TENNESSEE VALLEY AUTHORITY

In the Matter of the Application of) Docket Nos. 50-390
Tennessee Valley Authority) 50-391

ENCLOSURE 1
WATTS BAR NUCLEAR PLANT UNITS 1 AND 2
RESPONSES TO NRC QUESTIONS

ENCLOSURE 2
WATTS BAR NUCLEAR PLANT UNITS 1 AND 2
RESPONSE TO SER OPEN ITEM 14 - SECTIONS 9.5.5 AND 9.5.7

FIG 40.128-1
Lube Oil Circulating Pump Connection

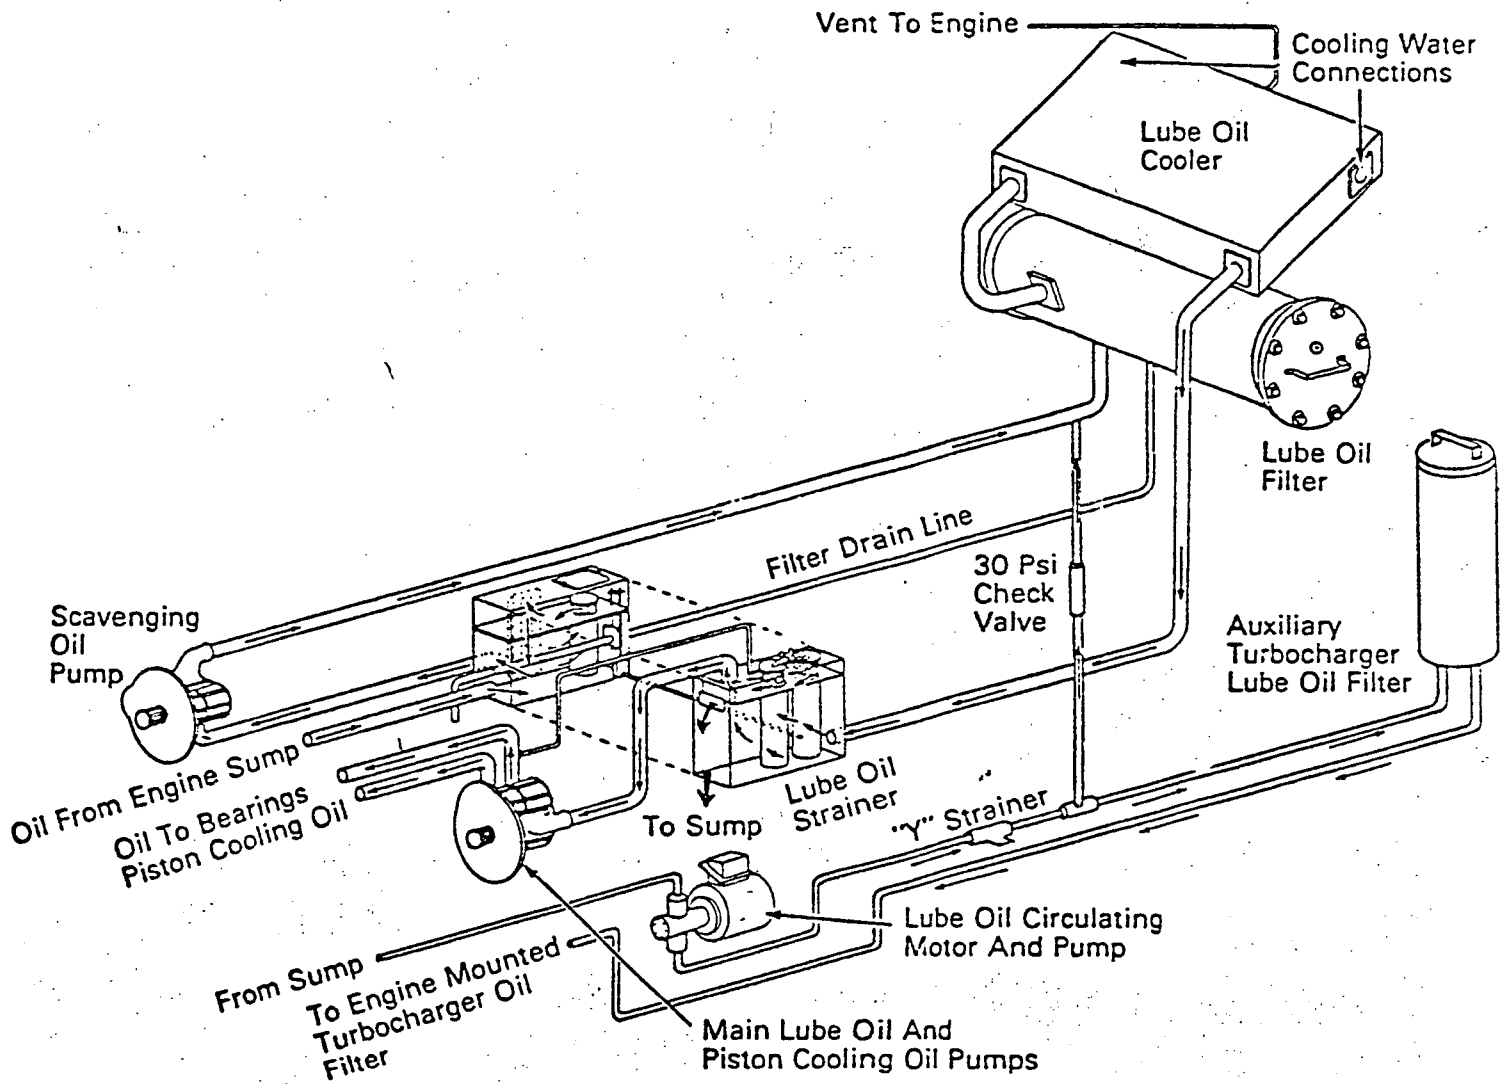
- B. We request you provide us with additional information with regards to the following areas of concern:
1. Diagrams and drawings in the maintenance manuals show the main bearing pump lube oil system providing lubrication to the camshaft rocker arm assembly and other upper engine wearing parts except the cylinders and pistons. The M.I. 9644 mods provide a continuous "Trickle" flow to the main bearing pump system. Indicate whether this trickle flow is sufficient to provide lubrication to the upper engine parts and the means used to prevent the oil from lubricating these parts during standby conditions. Also, provide a description with the appropriate diagrams of the lubrication system in the engine.

The engine lubricating oil system is a combination of four (4) separate systems for installation with turbocharged engines. FSAR Fig. 40.128-1 is a pictorial diagram illustrating the interaction between the cooling system and the lube oil system on a typical turbocharged engine. However, for a detailed schematic of the lube oil system supplied on these engines, refer FSAR Fig. 40.128-2.

The lube oil circulating pump draws oil from the oil pan and pumps it through a 30 psi check valve, in-line wye strainer, main lube oil filter, lube oil cooler, and is returned to the oil pan through the strainer housing. This system also serves to continously prelude the engine, the main engine oil galley stays full and the camshaft area is supplied through a separate exterior line. The pump operates continously.
